Easton Parish Council

Response Planning Application 2020/0962

The table below is an overview of our findings in relation to the revised layout plan EAS-PL01 Rev C

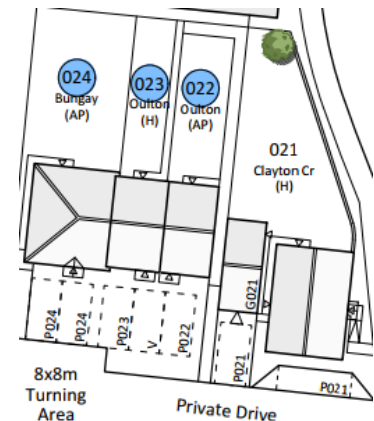
We are concerned that a verge area next to plot 196 becomes an unofficial parking area as such we would look for this to be designed out of the current layout drawing EAS-PL01 Rev C

Visitor spaces that are counted towards community accessible visitor spaces should not be positioned on private drives as this limits usability and may lead to conflicts between individuals. What are the rights of access to visitor spaces and who will maintain them? We have major concerns in relation to visitor spaces which have been positioned between the Oulton property types. Who will own and maintain them and who will have the right to use these spaces?

Properties affected by this potential flash point are plots **22/ 23/ 26/ 27/ 66/ 67/ 127/ 128/ 249/ 250/ 287/ 288 /289/ 290**, it should also be noted that these are all classed as affordable homes

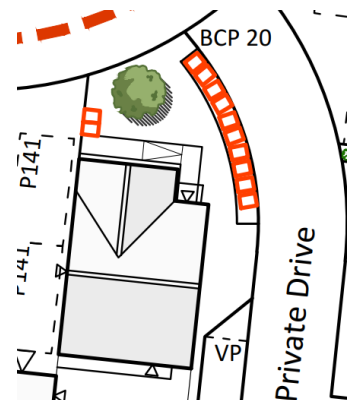
Bin blight continues to be a concern and needs to be designed out see South Norfolk Place-Making Guide SPD3.8.2. (Service and infrastructure elements), Environmental Protection Act 1990 s46 reinforced in Building Regulations 2010 H6 1.13.

Concerning the Refuse Plan EAS-PL04 Rev: B, a number of the bin collection points (BCP) are of concern as they may become unofficial parking or dumping areas. We are extremely concerned about BCP 20 which is on a private drive leading to six affordable designated rental properties and is positioned directly in front of Plot 141 and only a matter of meters from the front door. This is poor design and needs changing.

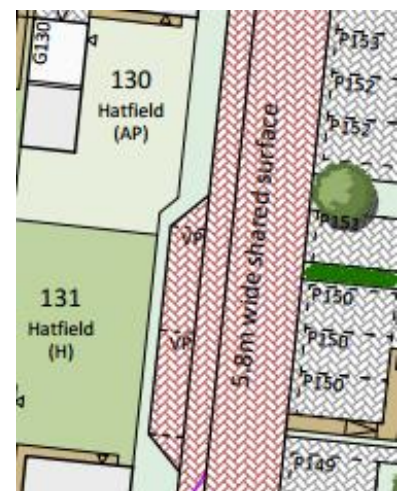
While we note on the layout design the inclusion of what looks like a pavement, we do not feel the design detail provides any level of comfort. The use of shared-space with low kerbs can cause problems for access, loading and turning. Not just for refuse collection but other large vehicles such as furniture delivery vans and removal lorries etc because cars parked on the kerbs limit the width of the road, especially for reversing and turning etc.

This can be seen as a potential breach of SNLP DMPD Policy 4.23

We also have further concerns that this is a token gesture as is clearly not designed for the safety of pedestrians as it puts them in direct conflict with other road users as illustrated the image showing visitor spaces on the inside of the so call safe footpath. This type of shared area is likely to be used as a parking area as it lacks definition from the rest of the road surface.

We refer you to our previous submission in relation to shared space usage on new developments. It is our considered opinion that a stand height foot path which is level and smooth is the most suitable solution for this area.

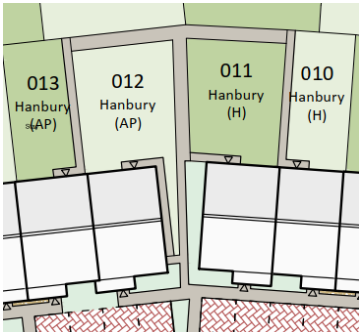
The Parish Council is pleased to note the low-level screening that is to be used at visitor spaces next to LAP’s. We would look to the Police to give further guidance on this matter.
